### Town of Kittery Planning Board Meeting September 12, 2019

#### ITEM 2 – 76 Dennett Road – Site Preliminary Plan Review

Action: Approve with or without conditions, continue consideration of or deny plan. Owners William J. Cullen and Sail Away, LLC and applicant William Wharff request consideration of a mixed-use residential development on 23.3+- acres of land at 76 Dennett Road (Tax Map 6 Lots 15B & 16A and Tax Map 13, Lot 4) in the Mixed Use - Neighborhood (MU-N) Zone. Agent is Shawn Tobey, P.E. Hoyle, Tanner & Associates, Inc.

# rical/Plumbing Closet

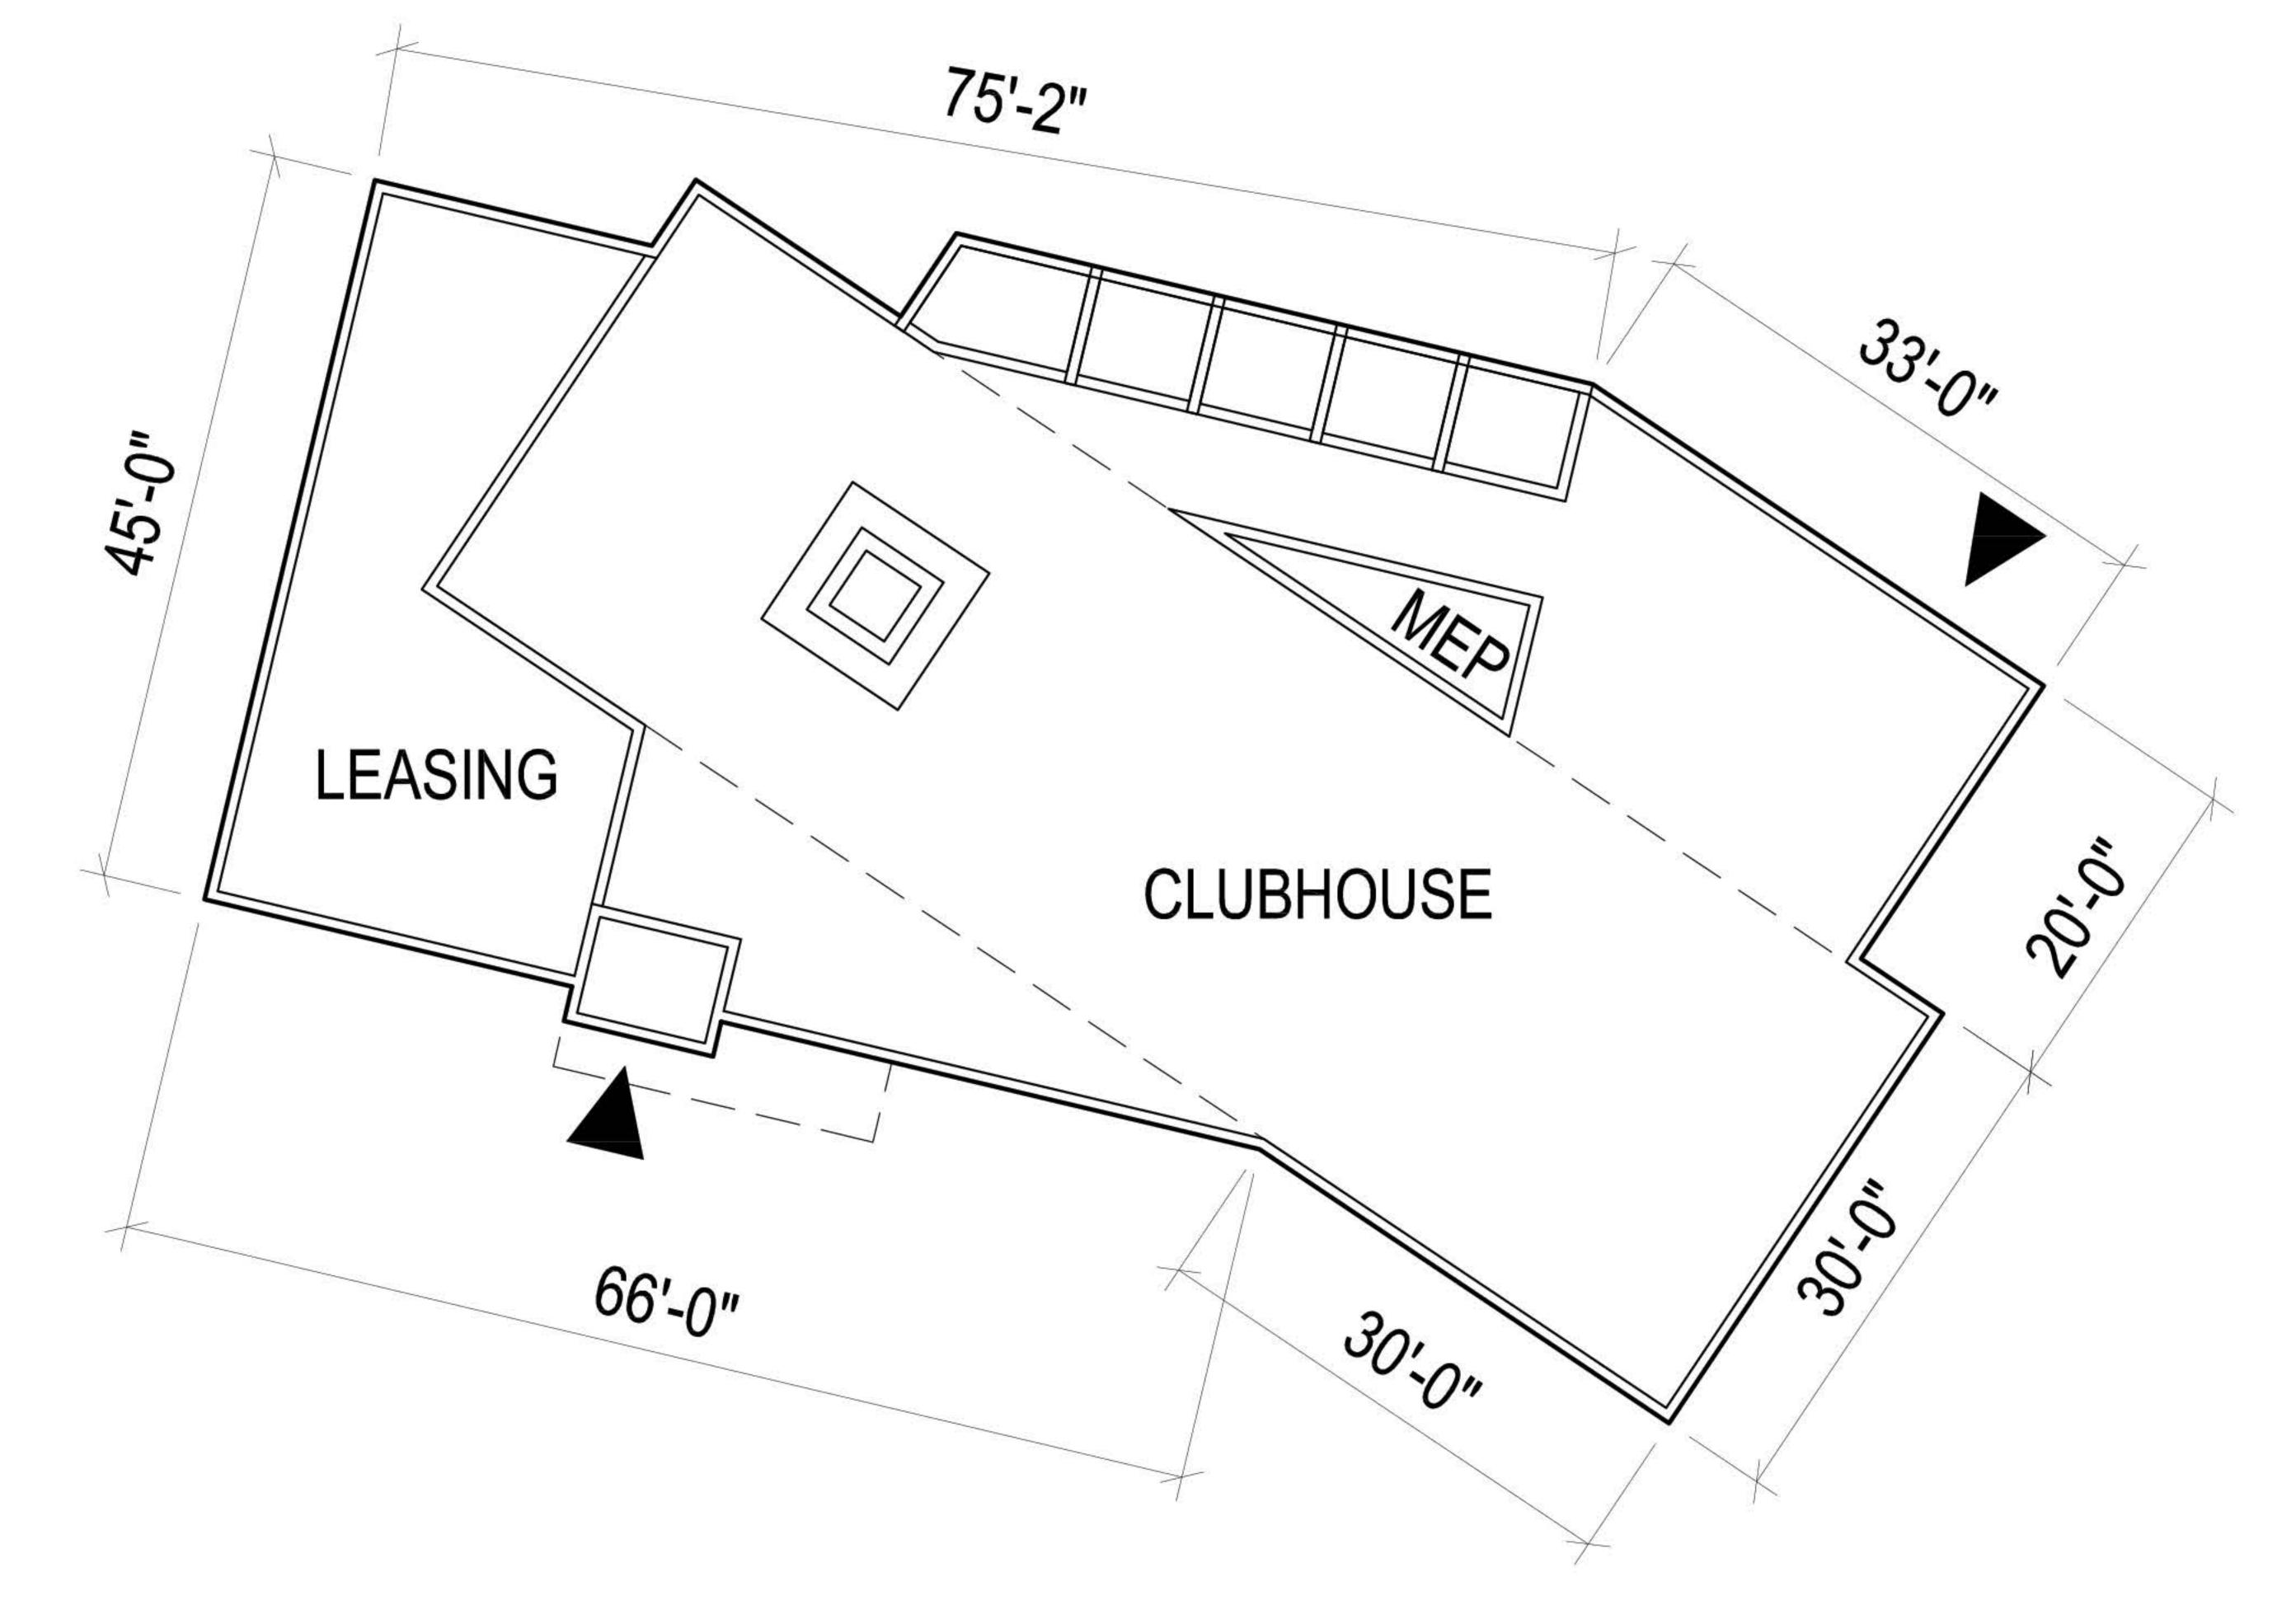
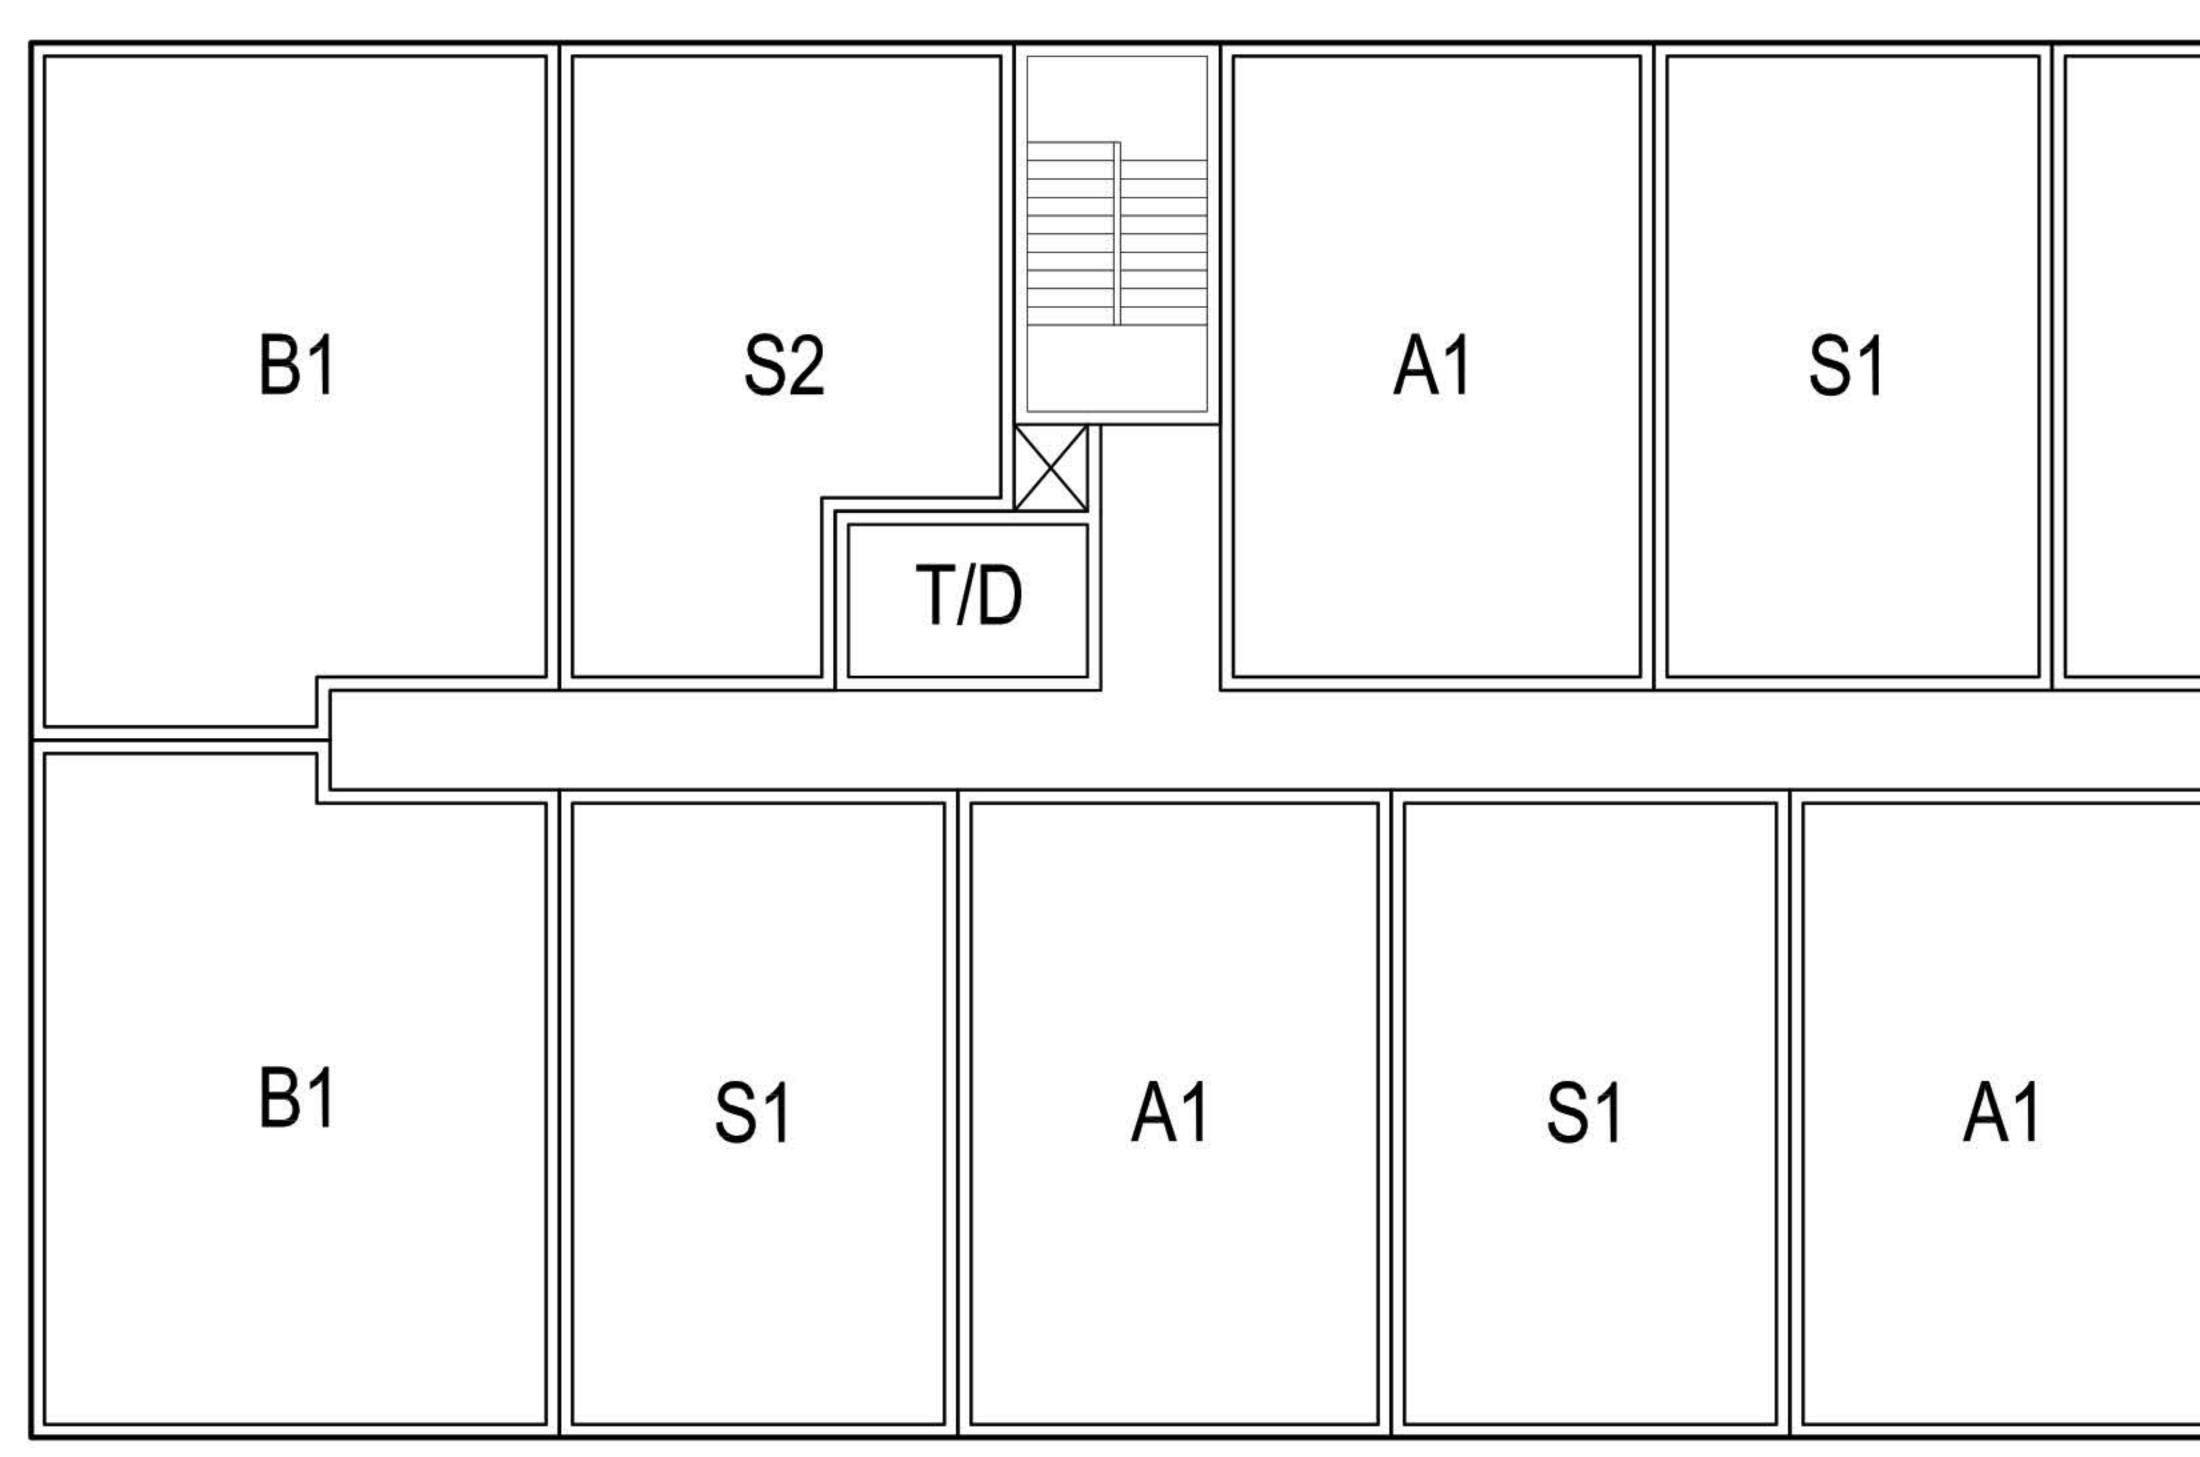
- 2. The Conceptual Floor Plans shall be revised to indicate that the studio apartments will contain a minimum of 650 sf of habitable space;
- 3. Completion of a third-party review of the proposed landscaping plans;
- 4. Provide details of the proposed sidewalk for the full length of the property for Final Plan review; and,
- 5. Address to the satisfaction of CMA Engineers their 2<sup>nd</sup> round of plan review comments.

- All studio units were revised to be a minimum of 650 SF.
- A legend was added.
- Dimensions depicting building heights were added to the elevations
- Building material callouts were added to the elevations.
